# The Design Review Panel

<b>Site</b>	23 Crescent East, Hadley Wood, EN4 0EY
<b>Proposal</b>	Demolition of existing house and erection of 7 flats with basement parking
<b>Local Authority</b>	Enfield Council
<b>Applicant</b>	PK Developments
<b>Agent</b>	Alan Cox Associates
<b>Review Date</b>	31st May 2023

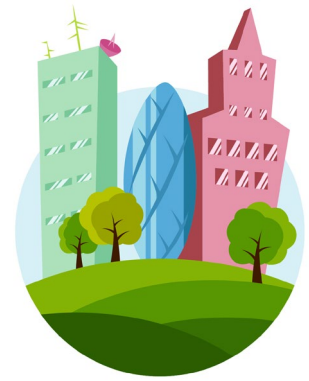
Considering the building from the perspective of a resident raises further thoughts about its design. While the entry is well-conceived and has been subject to considerable refinement, the rear elevation presents challenges. The flat roof over the three windows seems restrictive and detracts from the overall aesthetic of the building. A reconsideration of the building's plan, perhaps to a slightly T-shaped arrangement that would allow the gable front to run through the structure, might provide an opportunity for improvement.
